&a. Staff Report- Townhouse Design Standards Code Update

AGENDA TITLE: Townhouse Design Standards Code Update Discussion #2
DEPARTMENT: Planning & Community Development
PRESENTED BY: Catie Lee, AICP, Associate Planner

**PB COMMENTS
26 SEP 2019**

Option 1 Site Plan Result

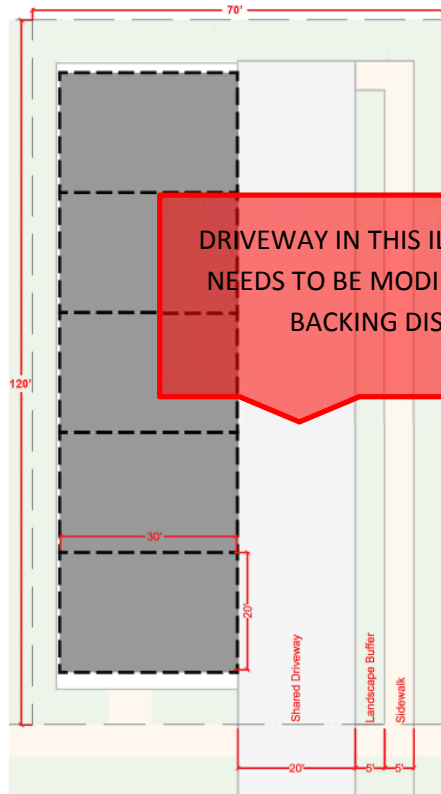
- Analysis:
 - *Option 1.* Assuming a single mid-block lot that is 60 feet wide, and the other code provisions that are proposed (e.g., landscaping, walkway) and current setbacks, it is not possible to get more than three (3) units on a lot this width and meet a 30% requirement.

- 60 feet wide minus 5’ landscaping on each side minus 20’ access drive minus 4’ walkway = 26 feet, this is only enough width for one unit (most developers are not building 13’ wide units in Shoreline).

- **Result:** This will only allow three (3) units to be built on lots 60’ wide or less, unless the units are very skinny (13’ wide or less).
 - *Option 2. Result:* If the proposal is a single mid-block lot, this will end up looking like the perpendicular buildings we’ve seen built recently, except the end unit facing the street will be oriented towards the street instead of the side. On lots with more frontage and/or assemblage of multiple lots this will result in more of the frontage being filled with buildings with units oriented to the street.

Option 2 Site Plan Result

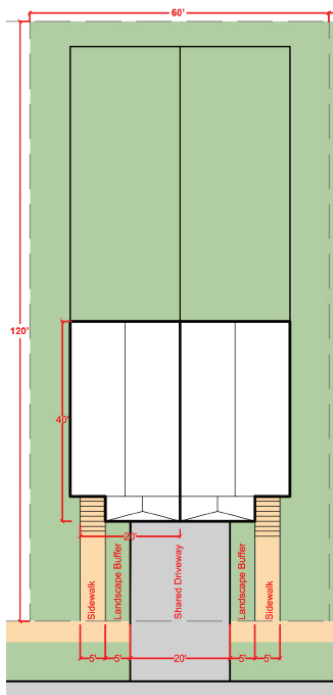
DRIVEWAY IN THIS ILLUSTRATION NEEDS TO BE MODIFIED FOR 23' BACKING DISTANT
